**FINAL DRAINAGE LETTER
FOR
LOT 1, WOODMEN HILLS FIL NO. 12**

December 2020

PCD Filing No:PPR-2049

DRAINAGE MAPS

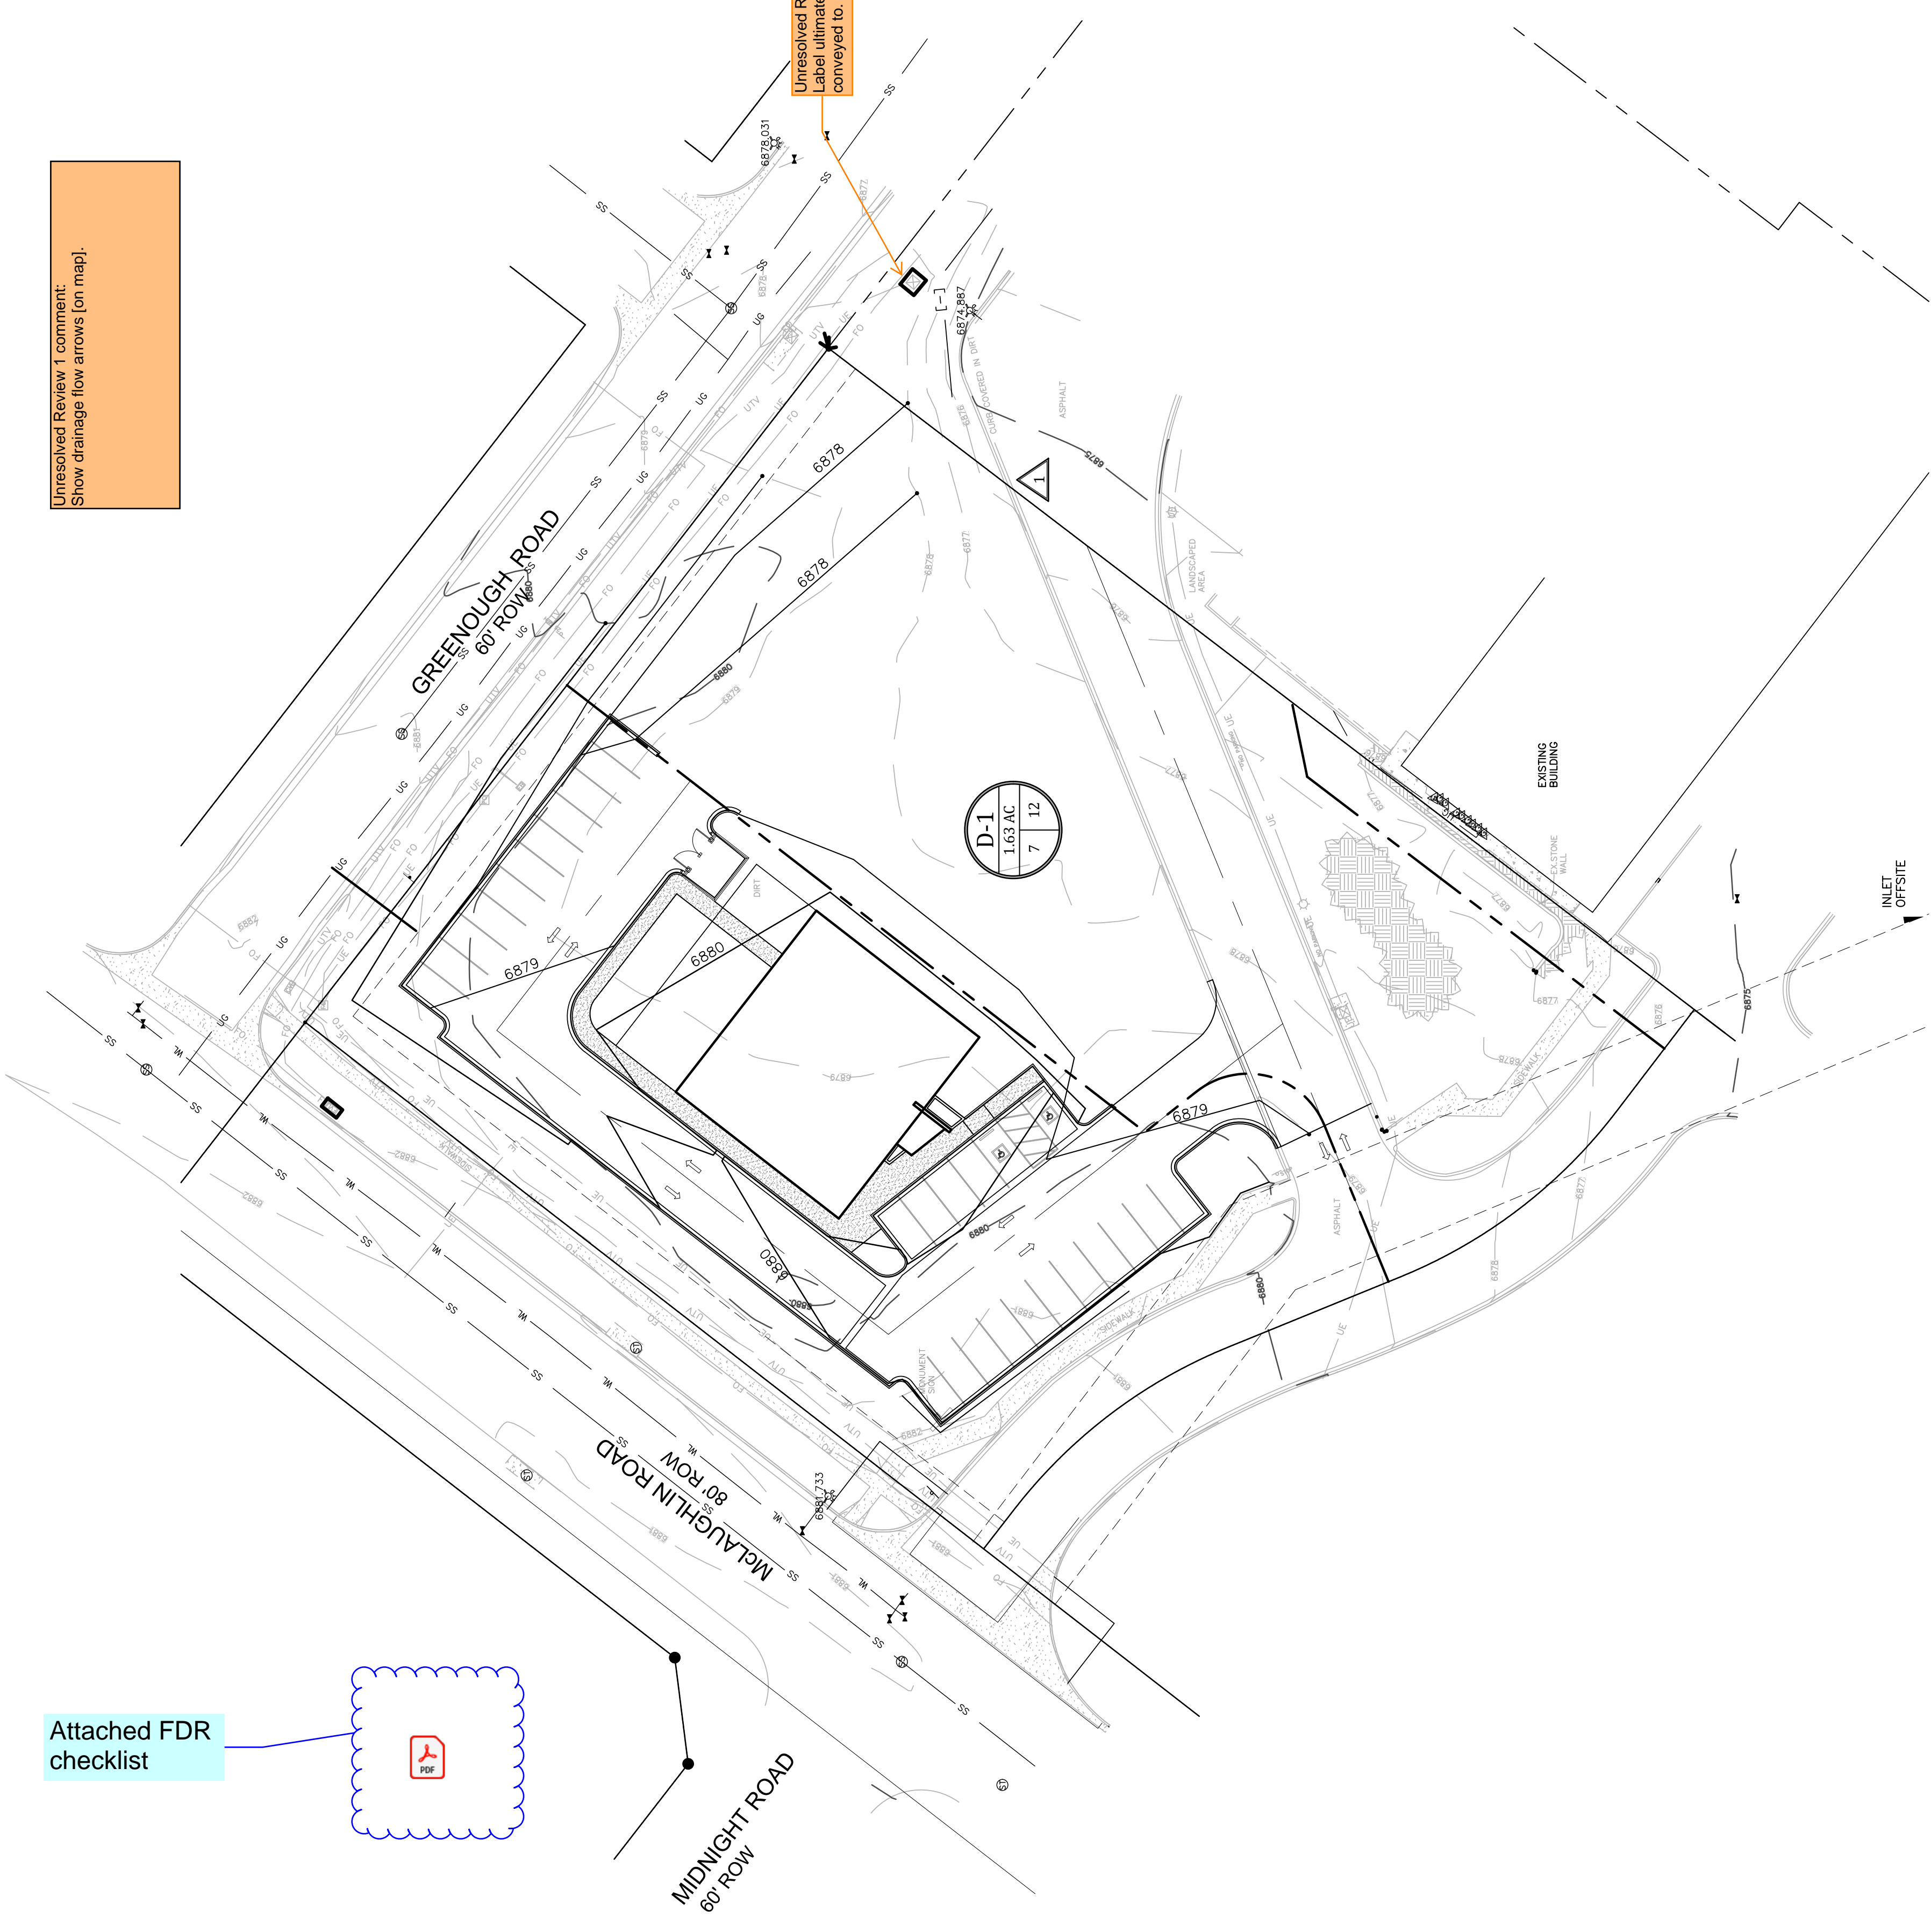
Unresolved Review 1 comment:
Show drainage flow arrows (on map).

Unresolved Review 1 comment:
Label ultimate inlet that site runoff is conveyed to.

Unresolved Review 1 comment:
Show drainage flow arrows [on map].

Unresolved Review 1 comment:
Label ultimate inlet that site runoff is conveyed to.
